Enclosure 1

COLA will be revised as shown in this enclosure. These mark-ups are based on COLA Rev. 6 and replace those provided in RAI 03.07.01-29, Supplement 1 in their entirety.

3H.10 STP 3 & 4 Resolution of Issues with Subtraction Method of Analysis Identified by DNFSB

Figure 3H.6-231: SSI, SSSI, ASCE 4-98 and Design Lateral Seismic Soil Pressures on Diesel Generator Fuel Oil Storage Vault No. 1A West Wall

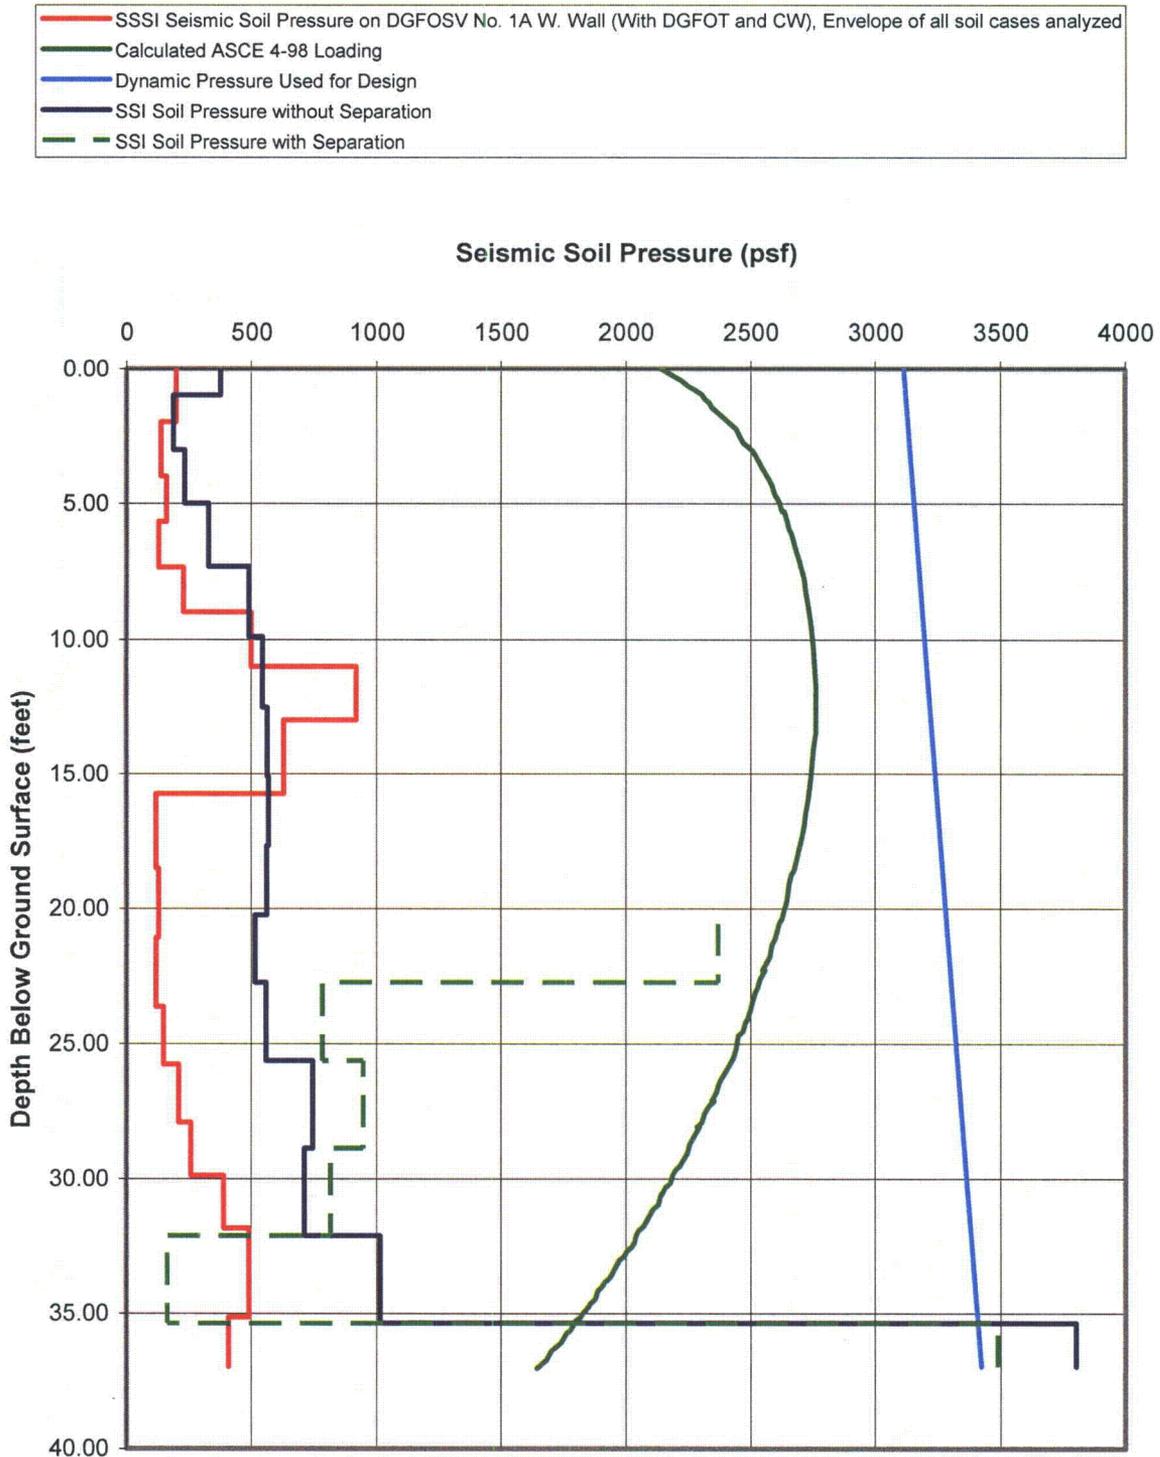
The SSSI analysis of the 2D model of DGFOV with other structures, which affects the DGFOV in the East-West direction is performed using SASSI2000 computer program, using subtraction method. For resolution of issues with the subtraction method of analysis identified by the Defense Nuclear Facilities Safety Board (DNFSB) see Section 3H.10. The following provides the details of this SSSI analysis.

The strain dependent soil properties used in the model are in accordance with the properties provided in Table 3H.6-1 for the in-situ soil, and Table 3H.6-2 for the backfill soil, with the exception that for soil layers below the ground water table, the Poisson's ratio is capped at 0.495 for determining the compression wave velocity. The thickness of soil layers are adjusted to provide a vertical direction passing frequency of at least 33 Hz (based on one fifth of shear wave length criterion).

Based on the site groundwater conditions originally described in FSAR Subsection 2.4S.12, the groundwater elevation of approximately eight feet below grade (26 feet MSL) was used in the analysis to determine the soil properties. Subsection 2.4S.12 and Table 2.0-2 now state the groundwater elevation as 28 feet MSL. Therefore, a sensitivity analysis of this change in groundwater elevation was performed using the Diesel Generator Fuel Oil Storage Vault SSI model, which showed no significant effect on the analysis results.

The incremental seismic soil pressures used in design, which envelope the incremental seismic soil pressures from the SSSI analyses and those computed per Subsection 3.5.3.2 of ASCE 4-98, are shown in Figures 3H.6-226 through 3H.6-231.

Figure 3H.6-138: RSW Piping Tunnel, Horizontal Response Spectra

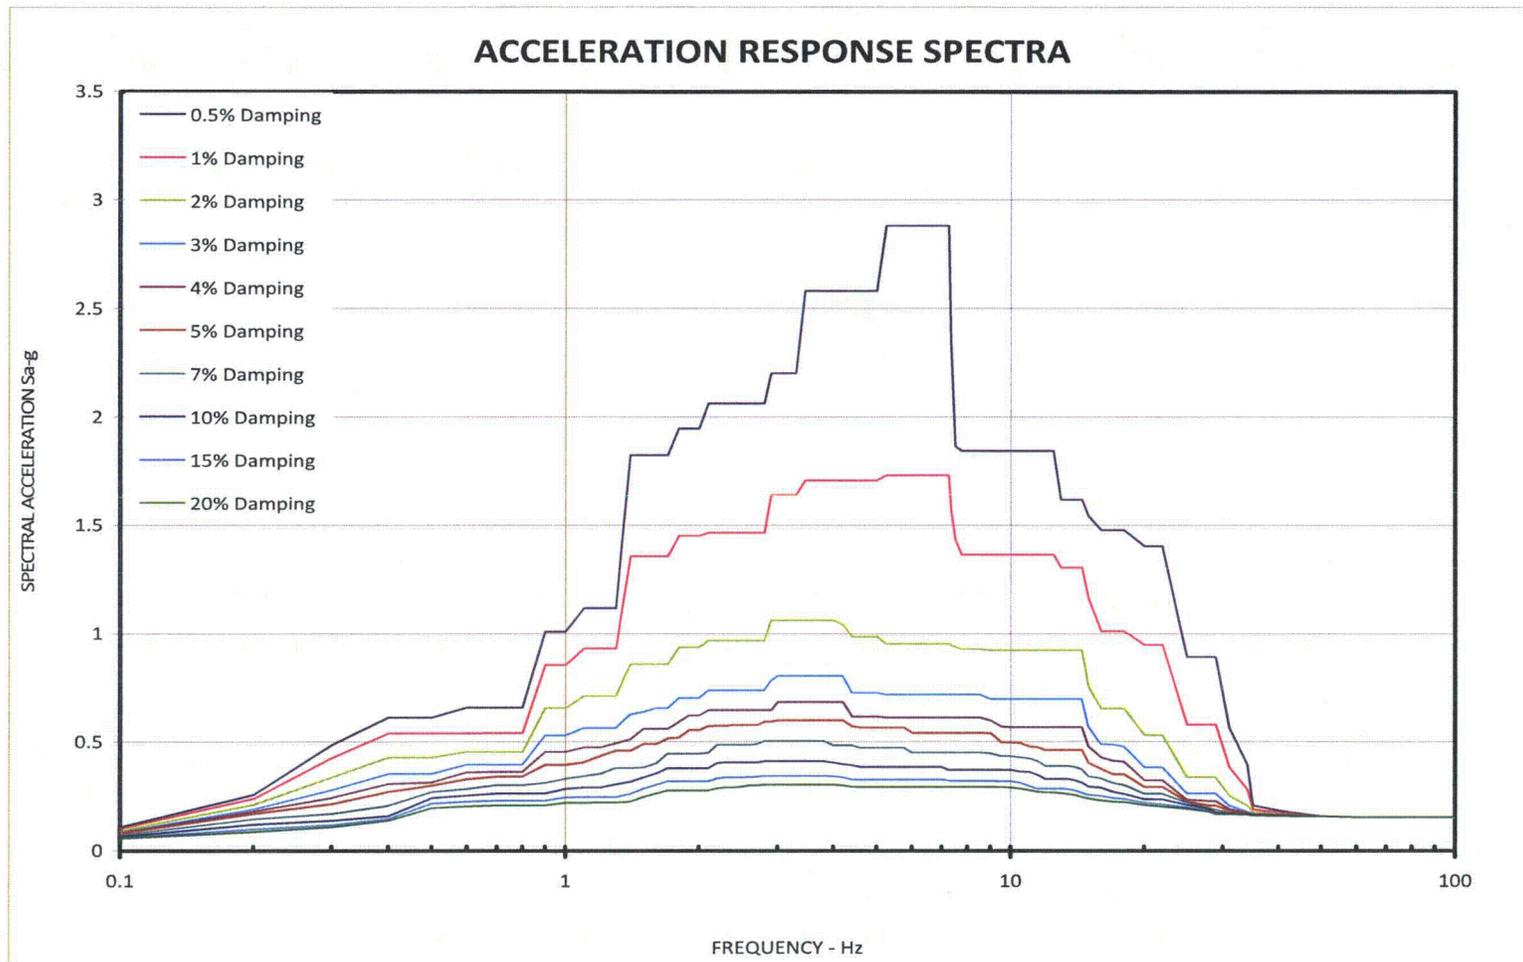
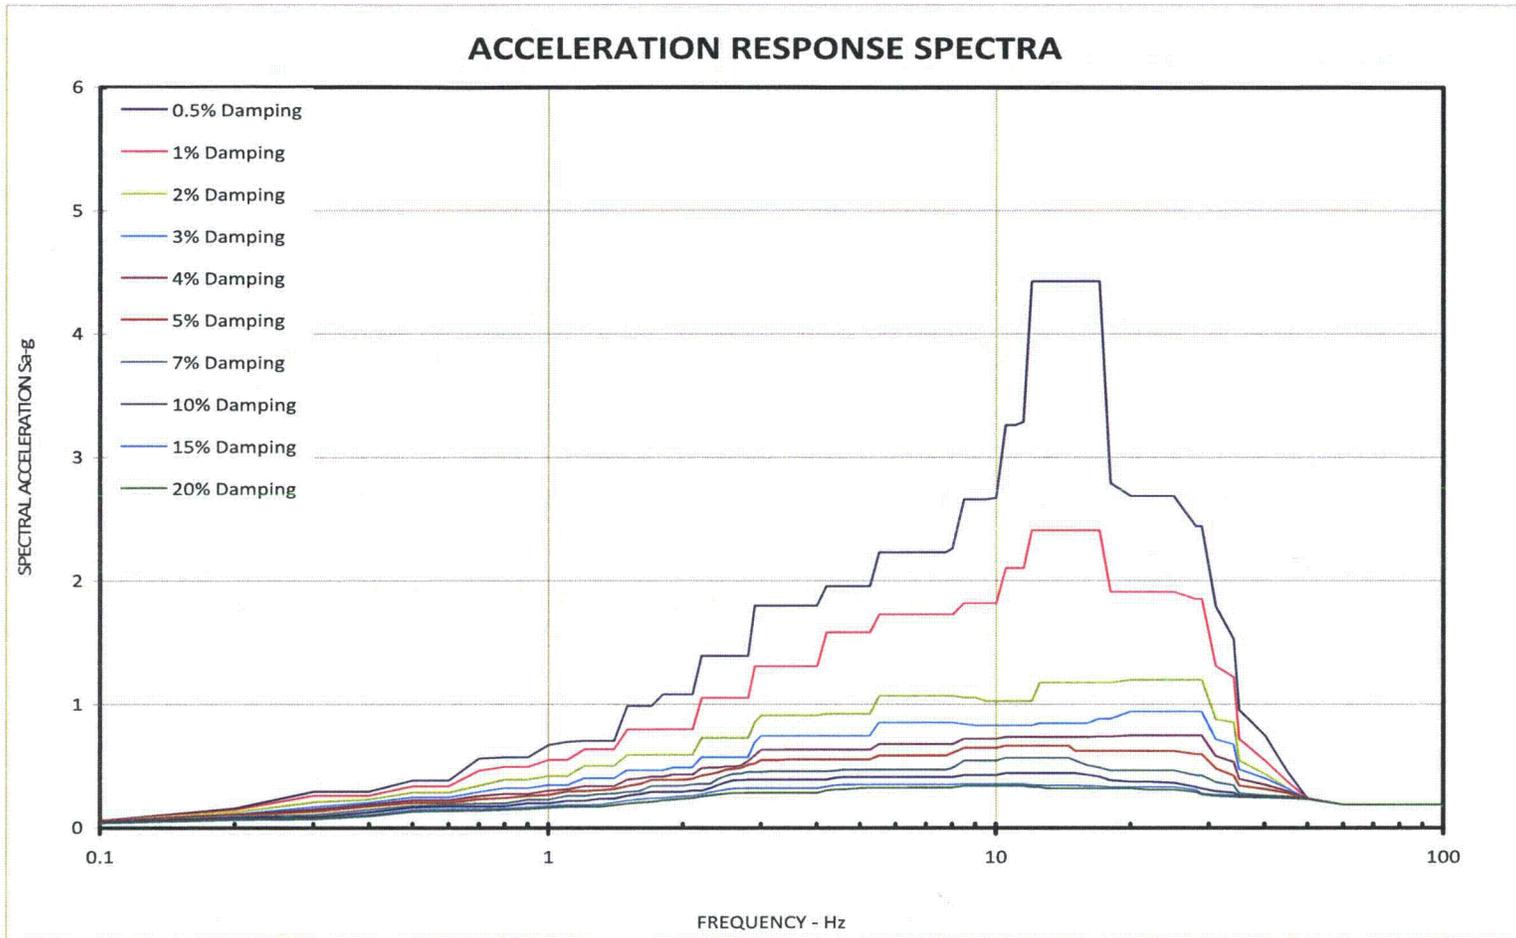
- Reactor Service Water (RSW) Piping Tunnel ISRS were generated using DM. Initially the amplified site specific SSE motions considering the effect of nearby heavy structures were obtained from SSI analyses of the Reactor Building (RB) and Ultimate Heat Sink (UHS)/RSW Pump House using SM. The SSI analyses of the RB (for all soil cases) and UHS/RSW Pump House (for upper bound in-situ soil case) were repeated using MSM. Based on the comparison of the RSW Piping Tunnel ISRS obtained from SSI analysis of RSW Piping Tunnel using amplified site specific SSE motions from MSM analyses to those from SM, increase scale factors were determined to account for the effect of MSM on amplified site specific SSE motions. The ISRS based on amplified site specific SSE motions from SM analyses were increased by these increase scale factors to obtain the final RSW Piping Tunnel ISRS.
